AUSTIN ROVER

TECHNICAL

Item 942

76. FRONT SEAT CUSHION COVER DAMAGED

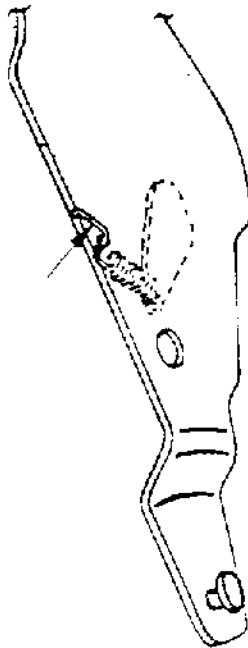
Instances of the front seat cushion cover being damaged by the squab tipping mechanism have been reported.

1. Remove damaged cushion cover.
2. Fit lock-down catch spring, JPC 8890, in place of existing spring, EAM 6783, to squab pivot plates on both sides, as illustrated.
3. Remove all sharp edges and burrs from squab pivot plates.

This modification was introduced on production at VIN 4'2335.

4. Fit new cushion cover.
